WSSC Ten Mile Creek Area Sewer Facility Study

Final Clarksburg - Ten Mile Creek Area Sewer Facility Study. The study area totals 980 acres within the Ten Mile Creek watershed, and lies within the 10 Mile Creek Limited Master Plan Amendment. The Facility study has been prepared for the Washington Suburban Sanitary Commission.

Figure 3-12 Alternative 12 - Gravity + 3 Pump Stations and Grinder Pump Systems (No Observation Drive)

Figure 1-3 Study Area and Downstream WSSC Sewers

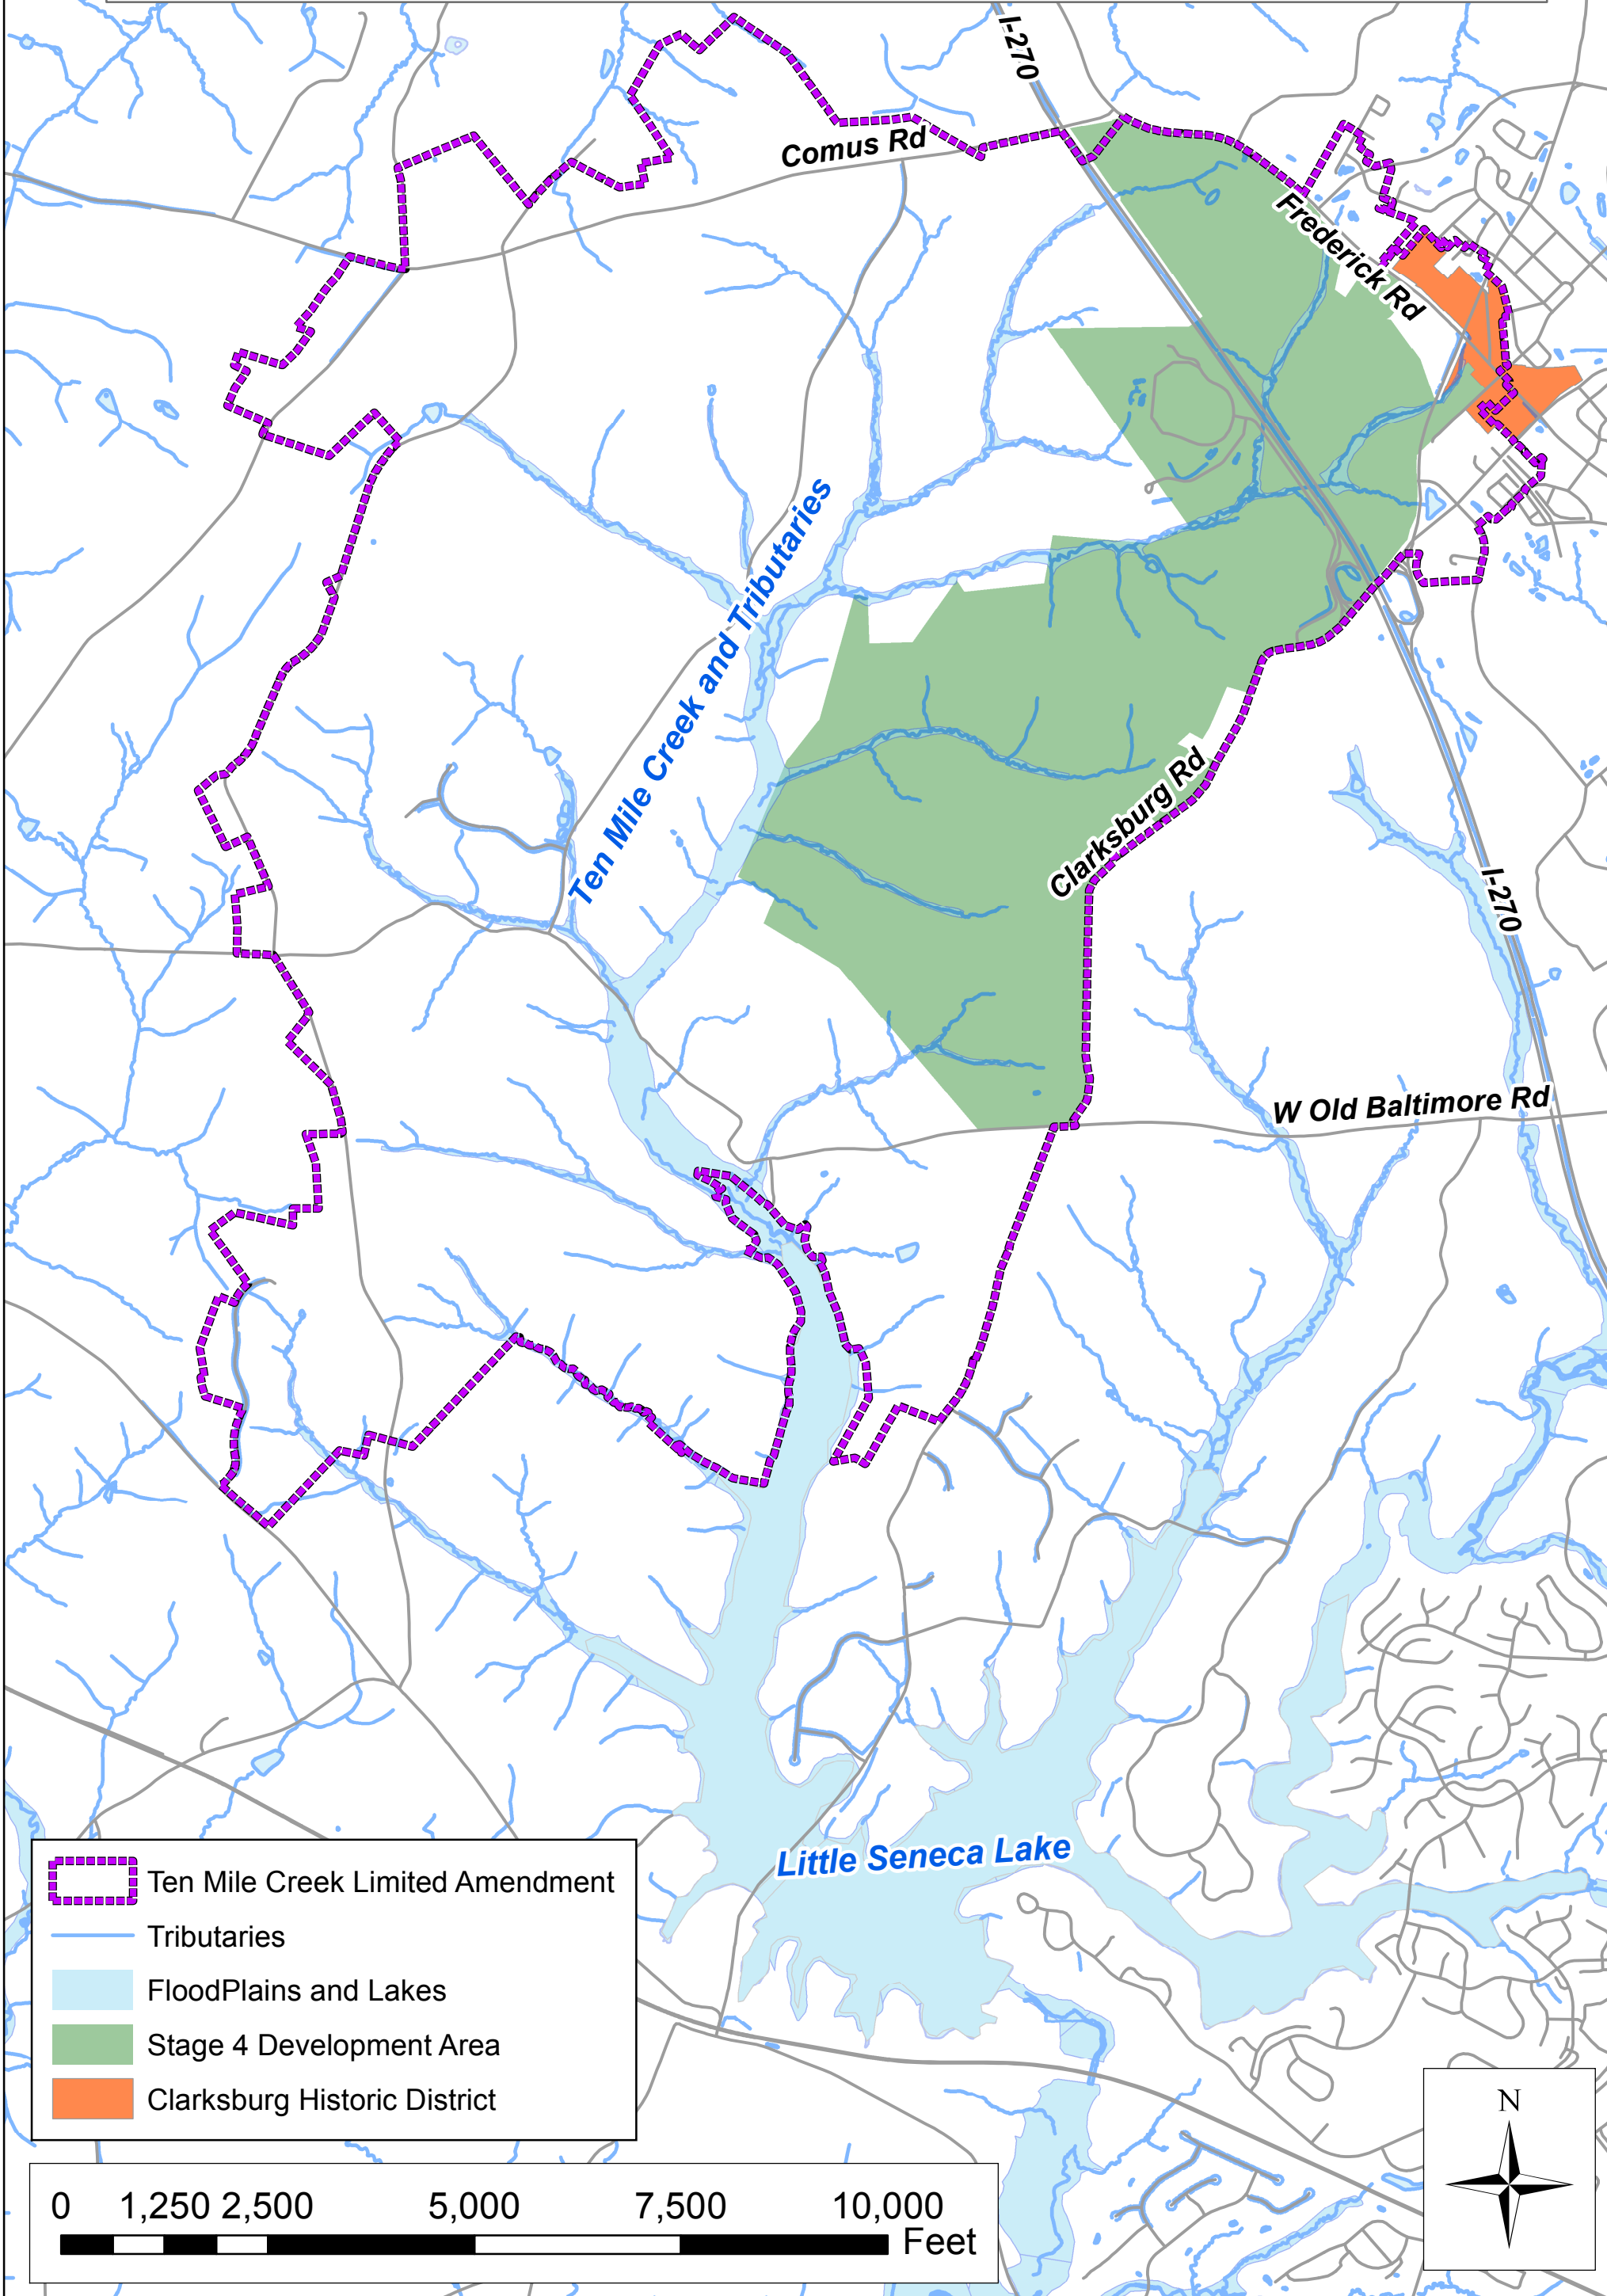
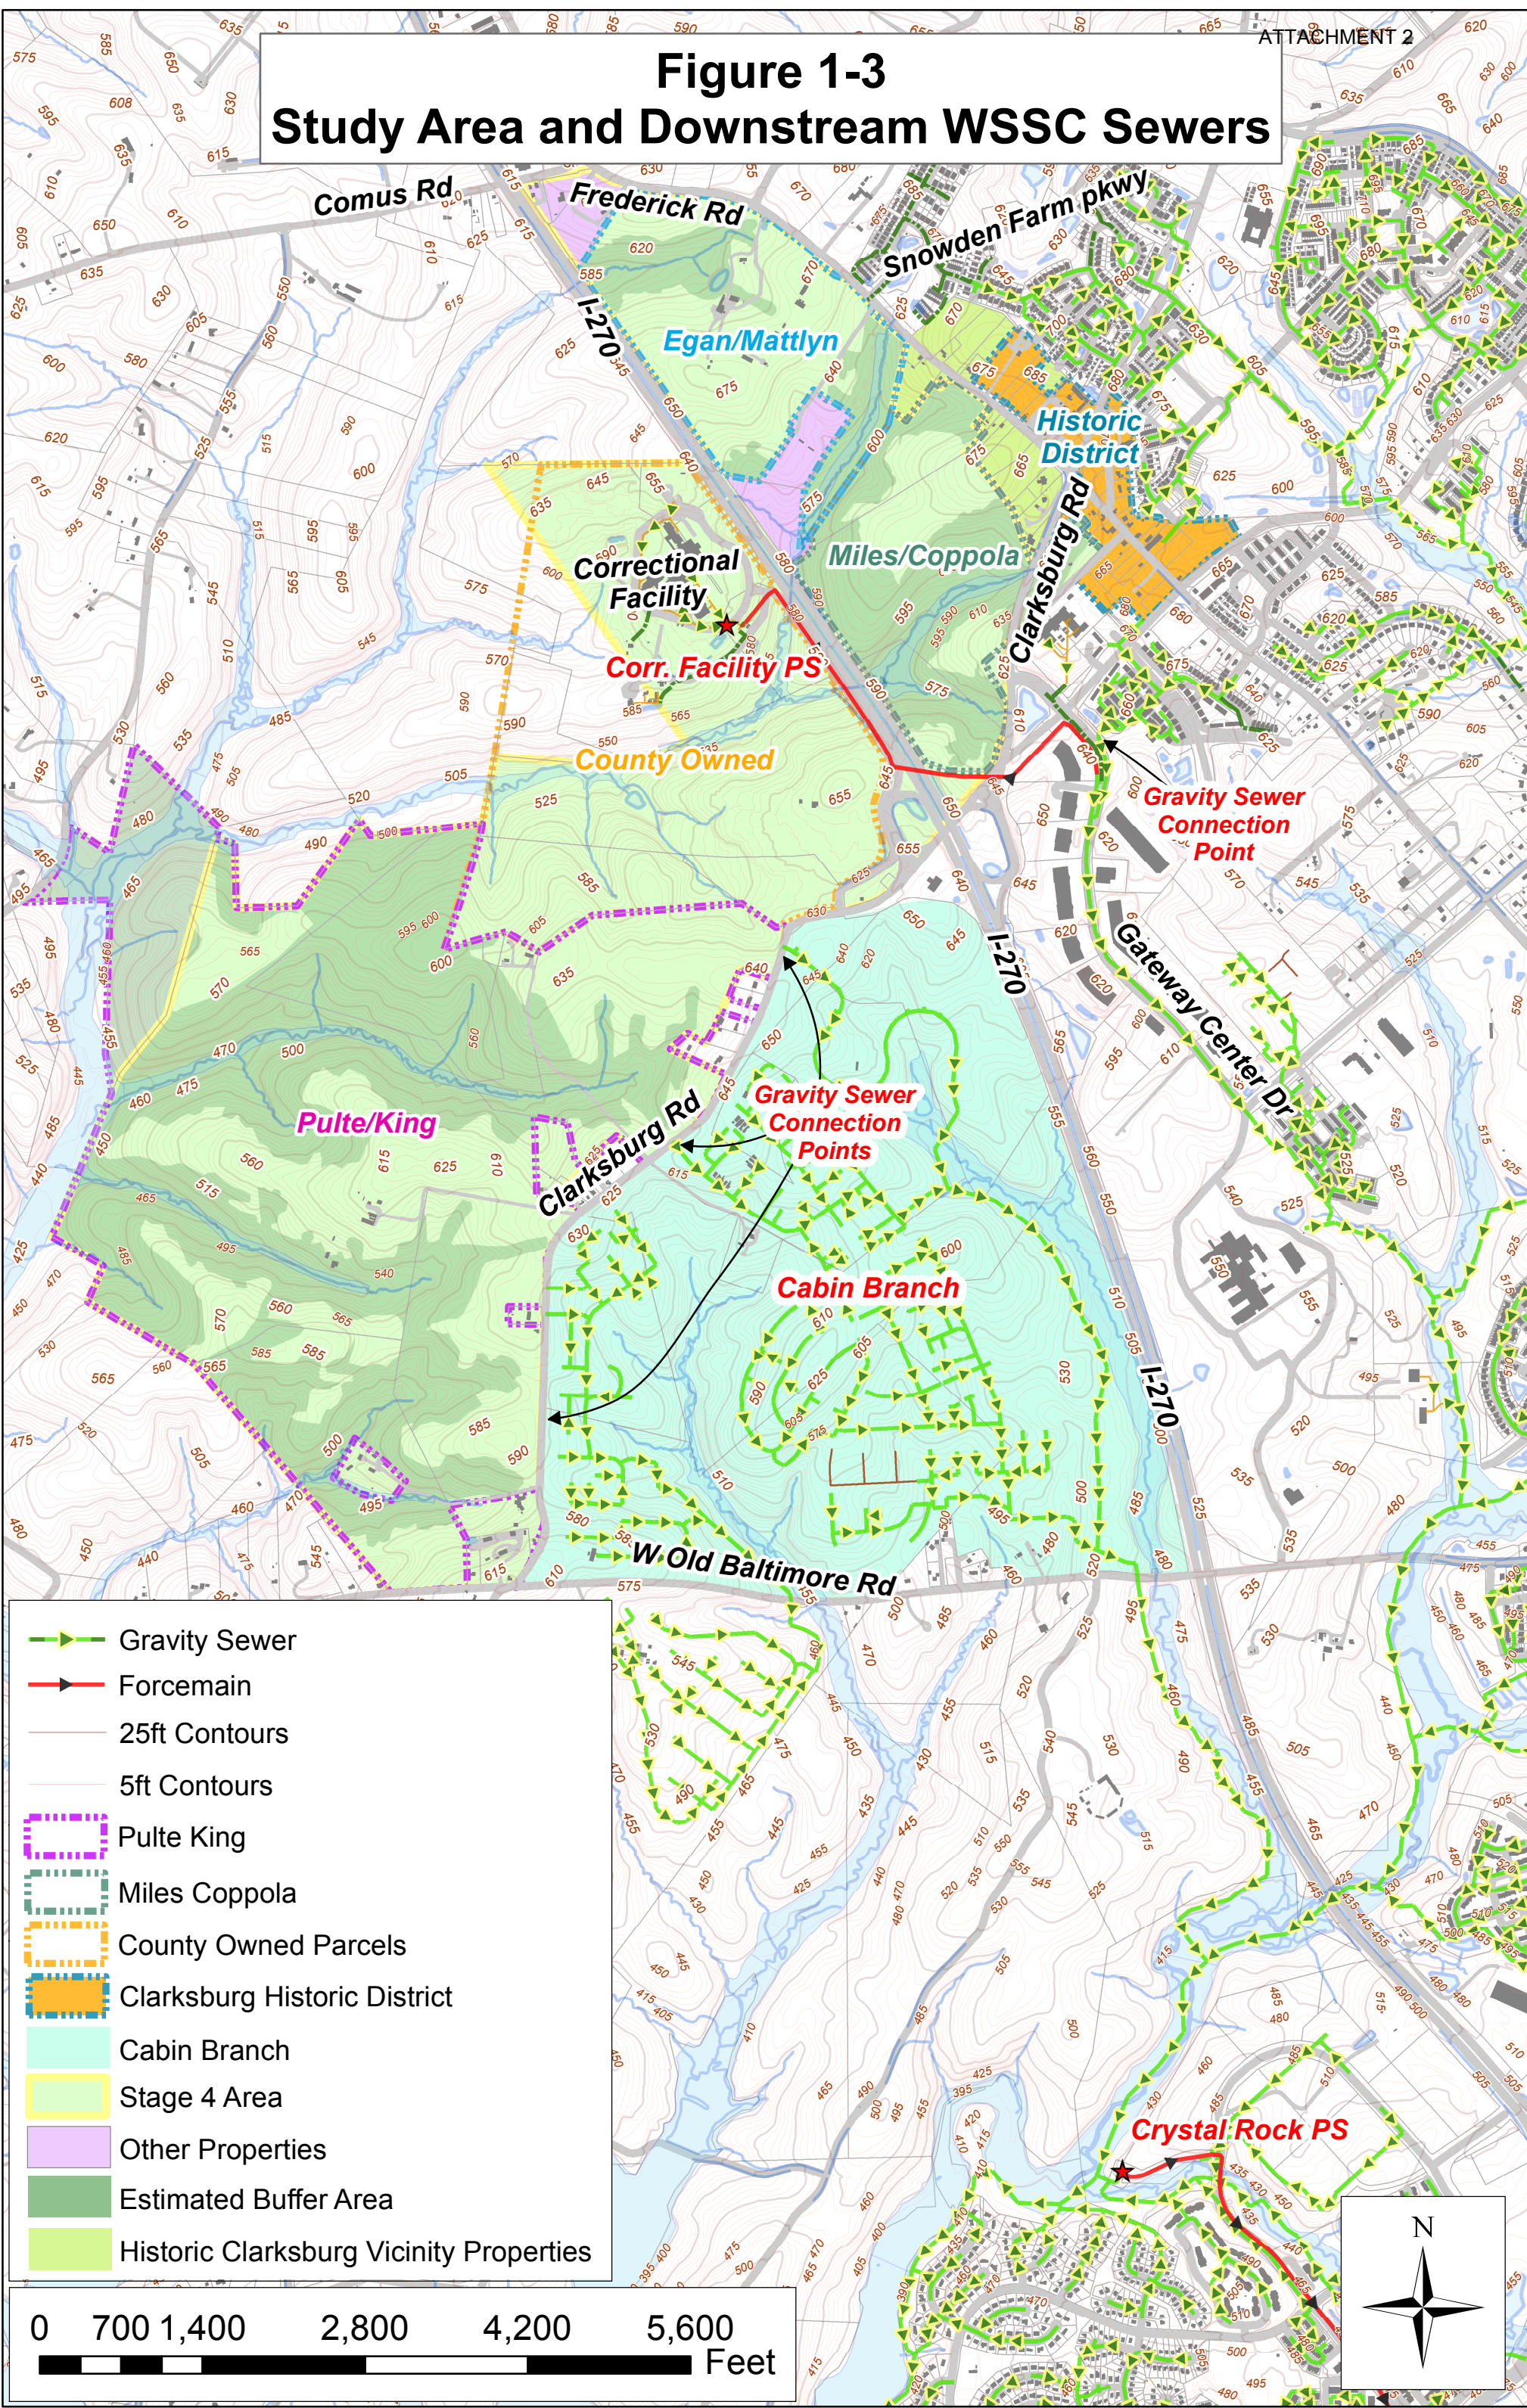
Number	Date	Representative/Party	Comment	WSSC Response
		Anne James, Cathy Wiss, (CAC Members)	<i>d) In Figure 1-3, WSSC shows anticipated bottlenecks in the gravity sewers along Gateway Center Drive. What are the plans to alleviate them?</i>	When new development plans are submitted to WSSC for review and approval, a Hydraulic Planning Analysis (HPA) is conducted to review available capacity in the downstream sewers and determines the necessity for a relief sewer. At this point in the process WSSC does not have the necessary information to determine when such a relief sewer may be needed.
42	12/21/2015	Katherine E. Nelson Planner Coordinator M-NCPPC	<i>1. Section 1, Page 1-3 - County Owned Properties – 220 forested acres of correctional facility are protected by a permanent conservation easement. Also, the future planned expansion is limited in scope and takes place within the current cleared area of the site. The County owns two vacant parcels that are not part of the correctional facility.</i>	Section revised in Final Draft Report to address the comment.

**Figure 4-1
Comparison of Forcemain Lengths**

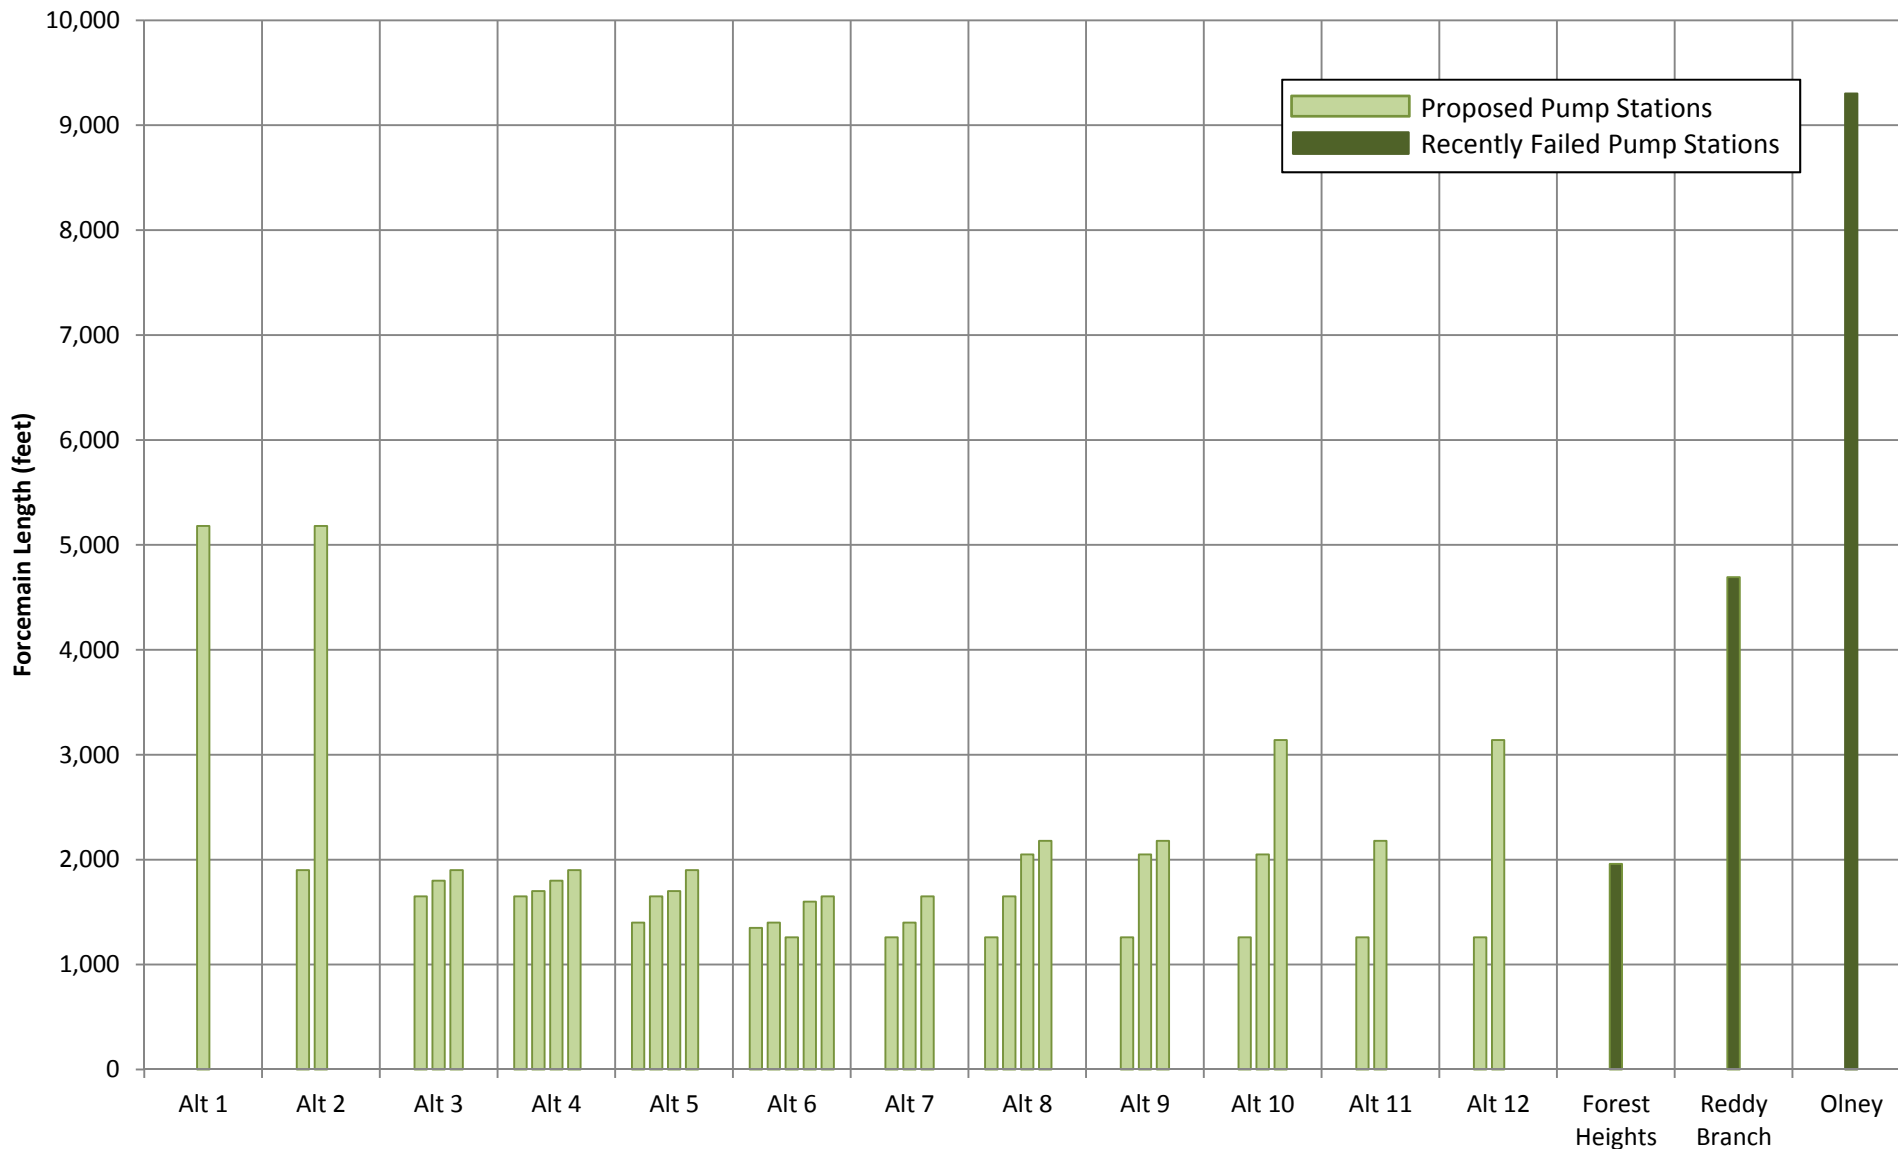
2	12/21/2015	Katherine E. Nelson Planner Coordinator M-NCPPC	<i>11. Figure 4-1 and 4-2 pages 4-14 and 4-15 – Should identify “recently failed” pump stations rather than “existing” pump stations. It implies that these are the only pump stations in the WSSC system.</i>	Revised figures 4-1 and 4-2 in the Final Draft Report to address the comment.
53	12/21/2015	Katherine E. Nelson Planner Coordinator M-NCPPC	<i>12. Figure 4-3 and 4-4 (the Preferred Approaches) – The graphics reference “Grinder Systems” and “grinder pump solution”, but the legend identifies “Low Pressure Sewer”. One term should be used when describing these systems, both on these graphics and in the text.</i>	Revised figures in the Final Draft Report to address the comment.
54	12/21/2015	Katherine E. Nelson Planner Coordinator M-NCPPC	<i>13. Criteria for the successful use of low pressure sewers should be provided by this study. At a minimum, examples of the successful use of low pressure sewers should be provided.</i>	Refer to WSSC SP ENG-04-10, Grinder Systems Policy and Procedure, as to successes we have achieved based on experience and meeting policy requirements.
